May 6, 2024

**RE: US Market Gas Station at 2115 Molalla Road (CU 24-01, DR 24-01, and ZA 24-01) Completeness Response**

RE: Status of CU 24-01, DR 24-01, & ZA 24-01 "US Market gas station" at 2115 Molalla Rd (Tax Lots 051W09B001000, 1100, & 1200 [primary])

**L100**

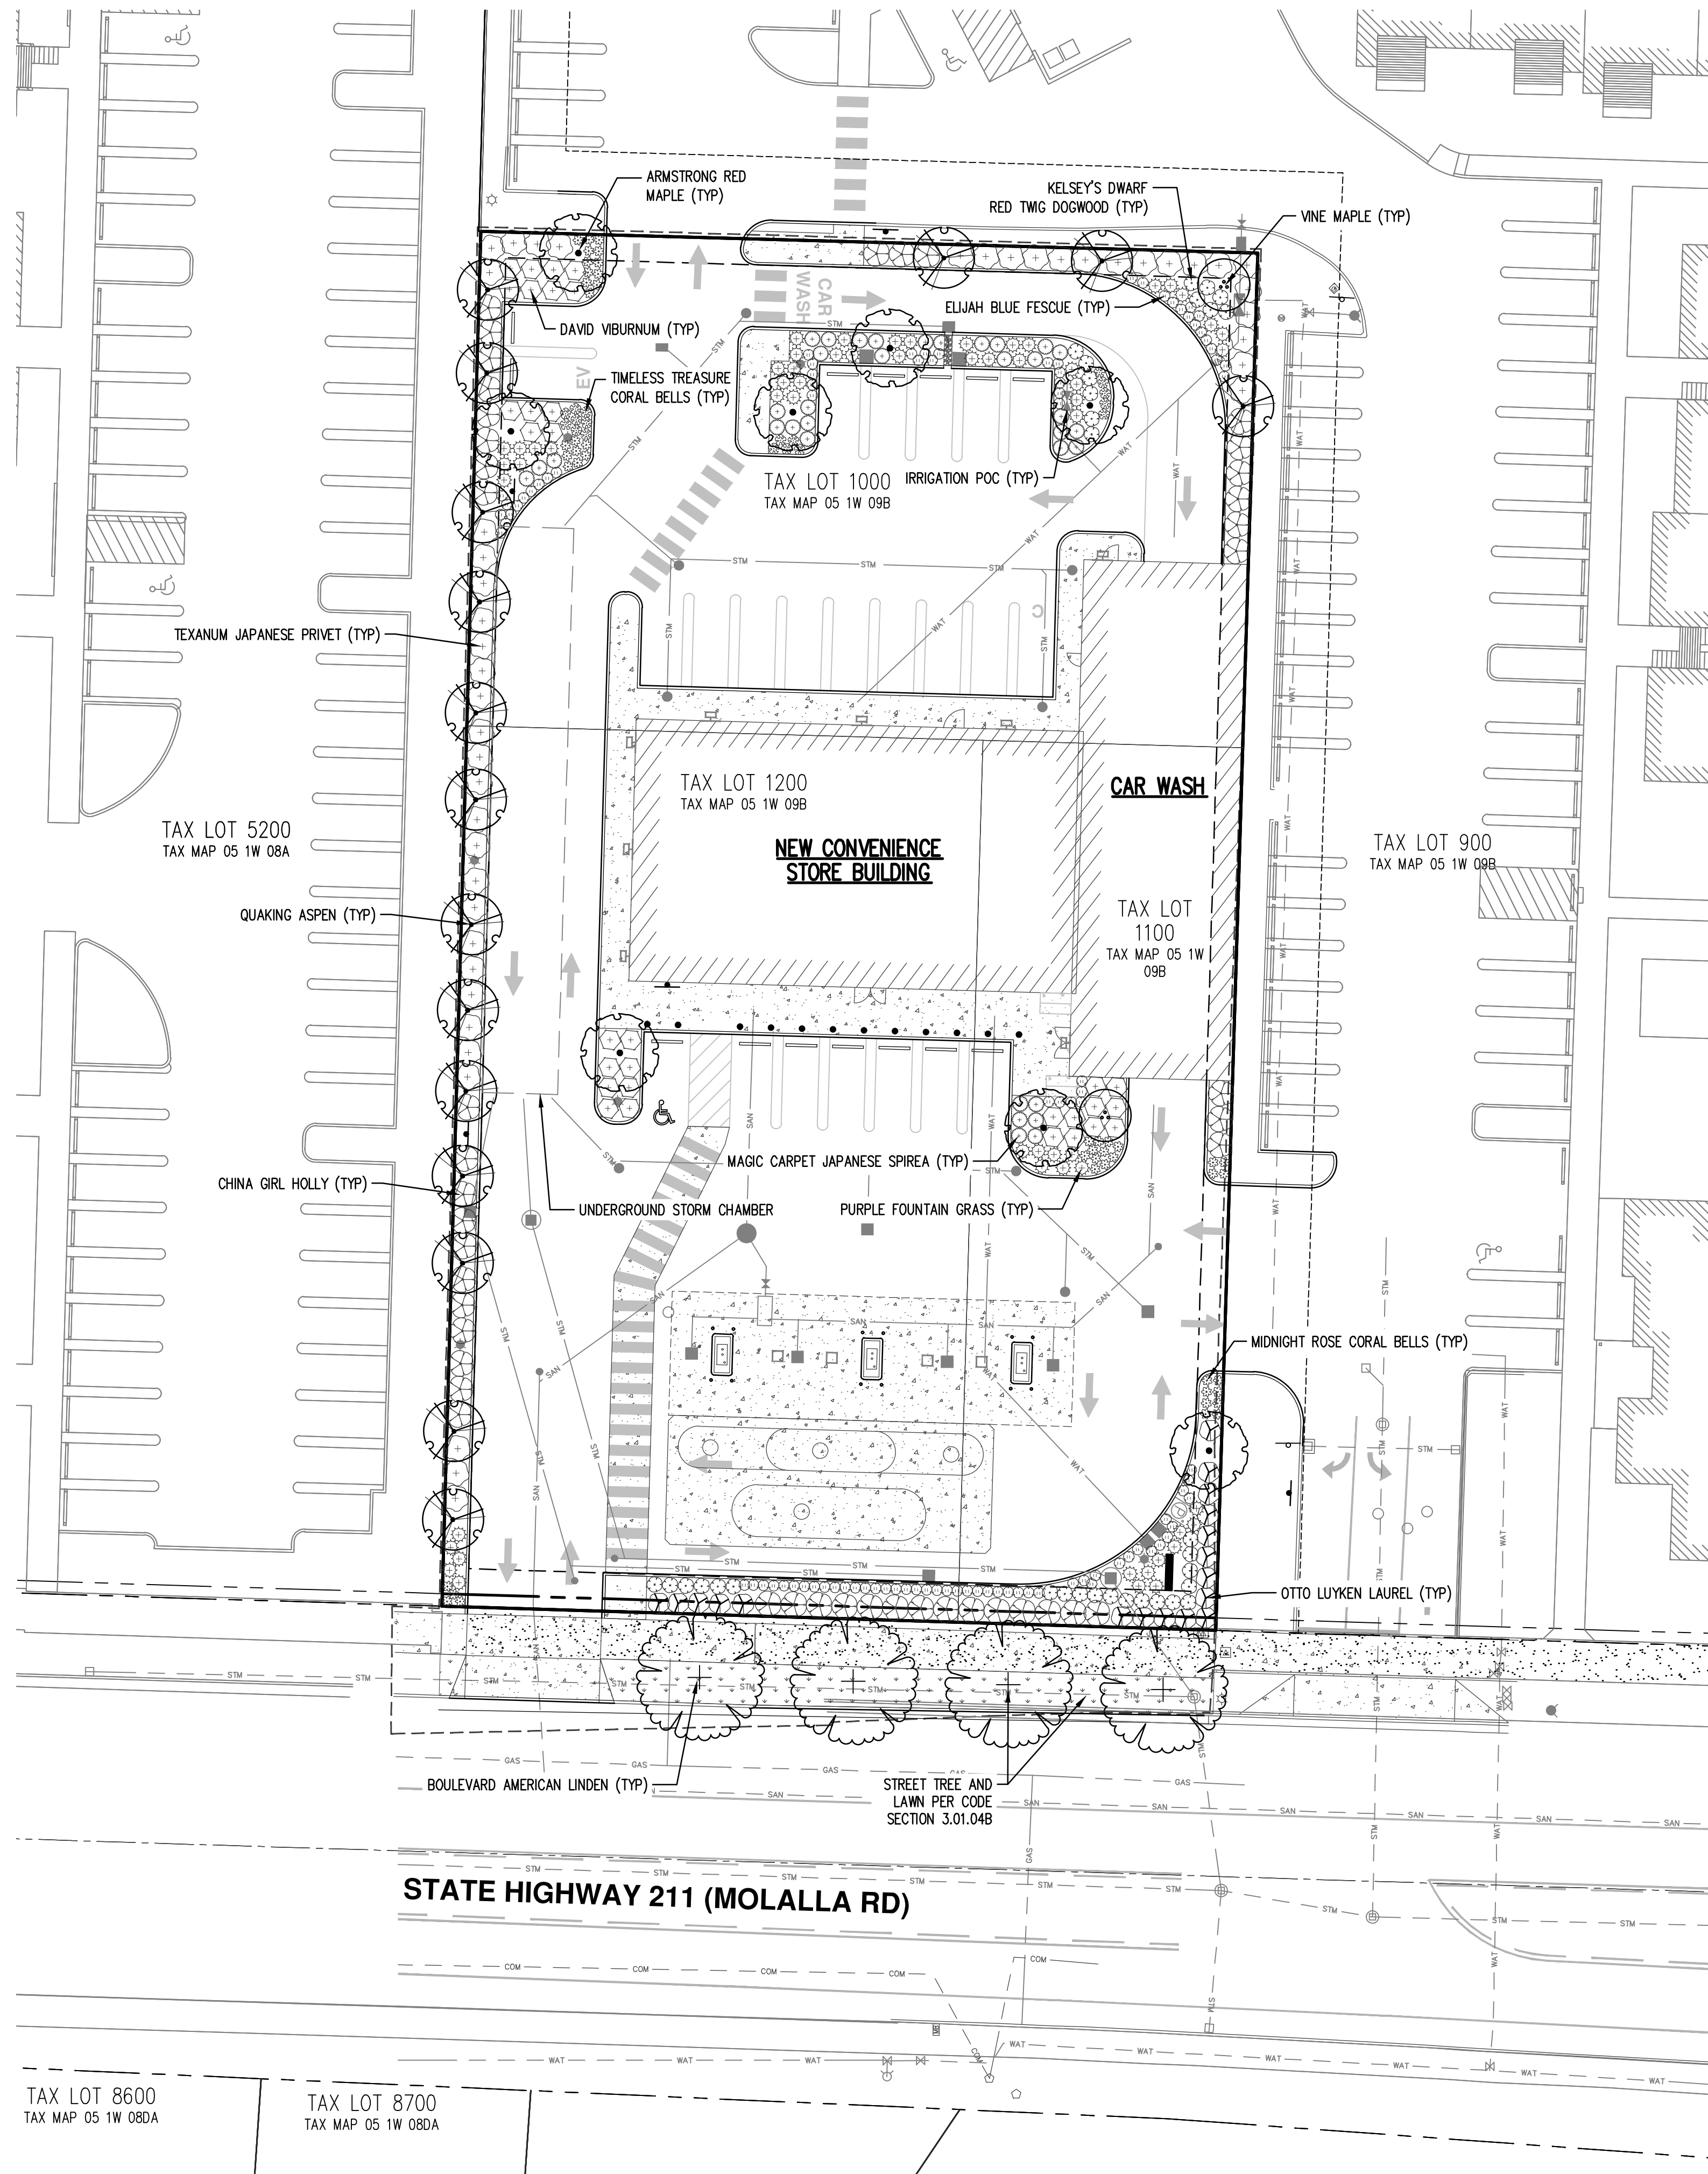
### *B. Frontage/street improvements: Revise the Sheet L100 landscape plan to:*

- 1. Indicate in the legend for each tree species either the size category at maturity as Table 3.06B describes or height in feet at maturity.*

The revised landscape plan (Sheet L100) illustrates and notes the proposed street species as one reaching a mature height of 45 to 50 feet (ft). WDO Table 3.06B row 3 defines medium size category at maturity as 40-60 ft height.

3.06.03A.2a requires along the highway, which is “Major Arterial” class, large trees. Table 3.06B row 2 defines these as 60-120 ft height.

Revise the street tree species to a large one.

EE. Front yard trees: Looking ahead to conditioning, to better buffer the gas station from the south, please revise the site plans to:

- (1) Deepen the front yard landscaping by 3 ft and add a row of at least 3 trees to complement street tree locations; and
- (2) Add to the highway landscape strip, between street trees, a row of evergreen shrubbery of at least 21 plant units (PUs) of small to medium size category at maturity as Table 3.06B defines.
